**Ontario Power Generation Inc. -  
Darlington Waste Management Facility**

Application to Renew the Class IB Waste  
Facility Operating Licence for Ontario Power  
Generation in Darlington, Ontario

# Ontario Power Generation's Application for the renewal of its Waste Facility Operating Licence for the Darlington Waste Management Facility

January 2023 Presentation to the Canadian Nuclear Safety Commission

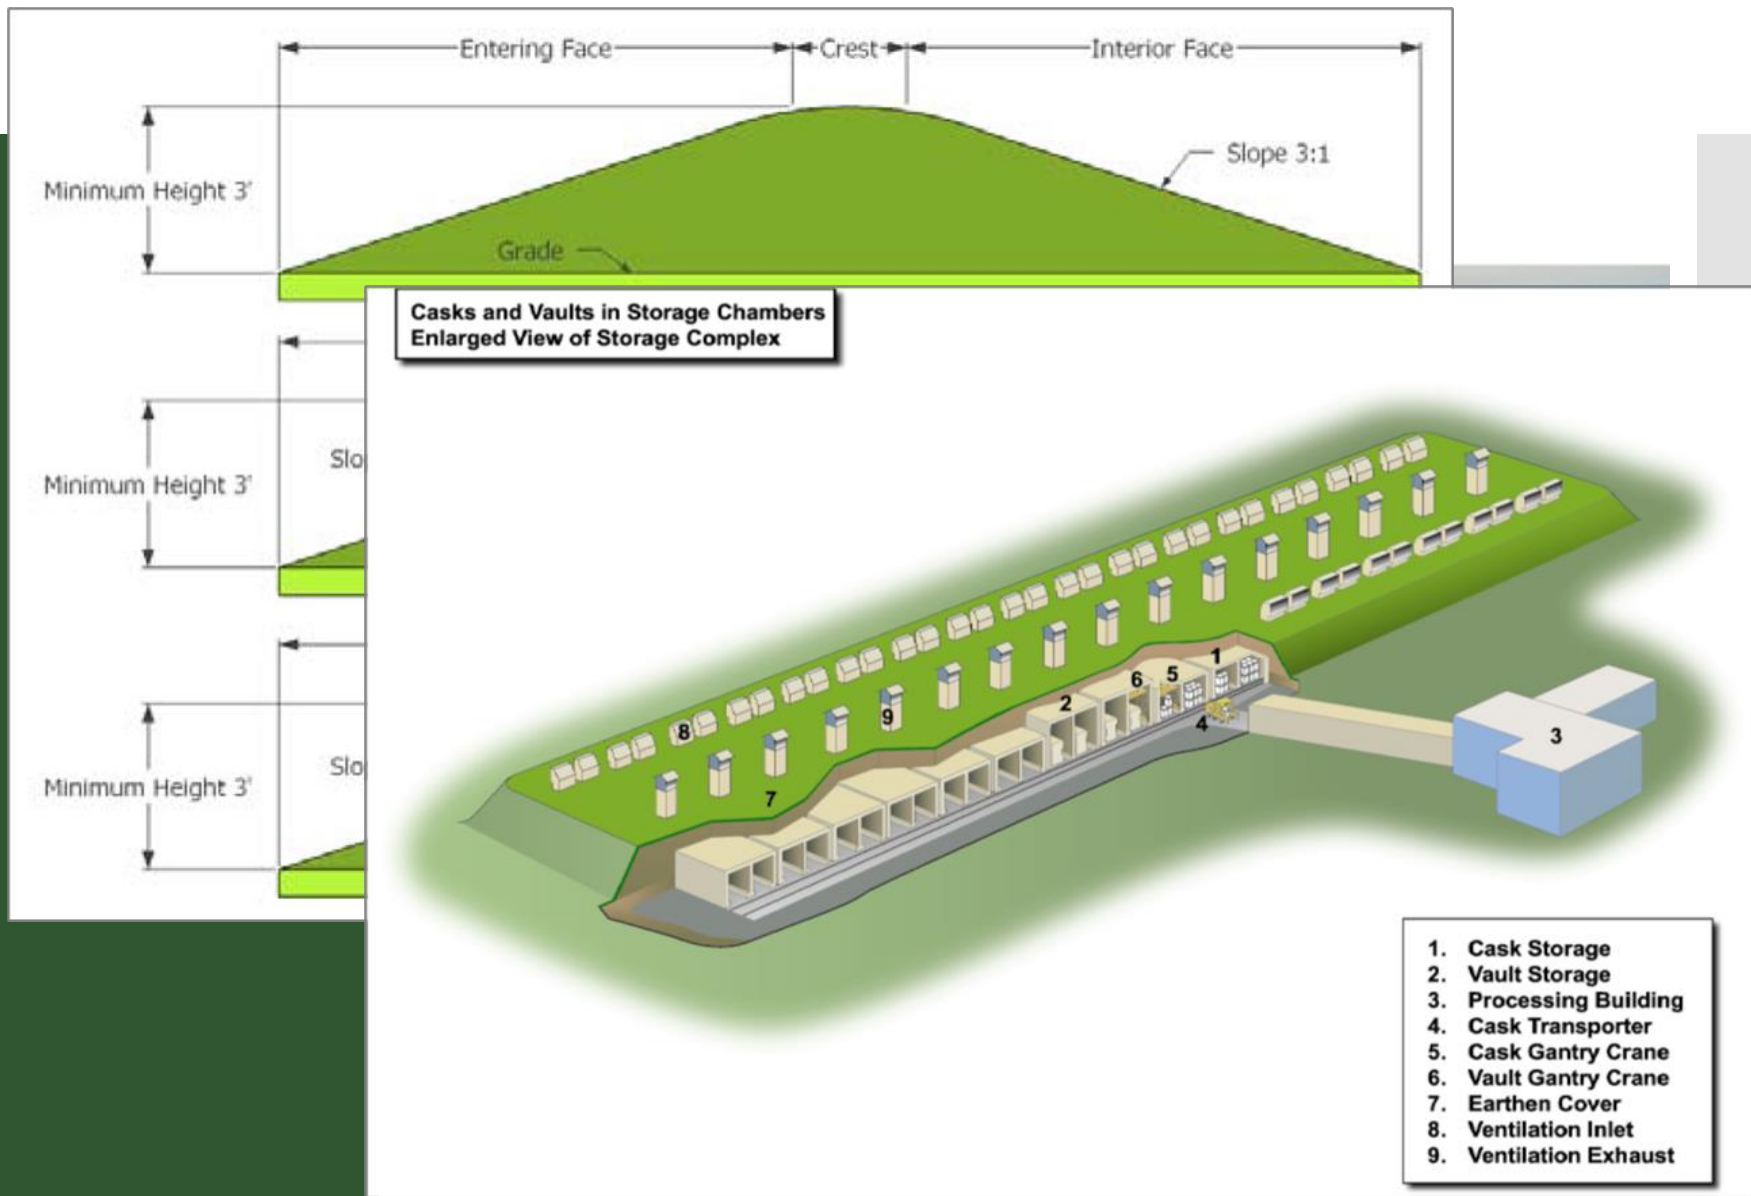
- The Darlington OPG Dry Storage Cask is an unventilated closed container with practically no means of convective heat removal from the spent fuel bundles encased in storage tubes.

- There are horizontal surfaces for excess water to pool and be absorbed into, and present challenges to evacuation of water by vacuum drying.
- A spent fuel dry storage system is required to dissipate fuel decay and chemical heat by convection of the enveloping gas moving around the fuel elements within the bundles. However, this OPG DSC design does everything to inhibit convective currents around fuel elements by first encasing two bundles in a tube

- There are no mechanisms or processes in place to identify defected bundles in the DSC
- A tightly packed horizontal placement of 384 uncatalogued spent fuel bundles inside a closely spaced pile of tubes within the enveloping concrete container is not conducive to convective heat removal; this is a serious DSC design weakness.

That the review of design and design characteristics of the additional used fuel storage buildings/structures, the preliminary safety analysis report, the environmental management plan and the construction plan should all be subject to public review.
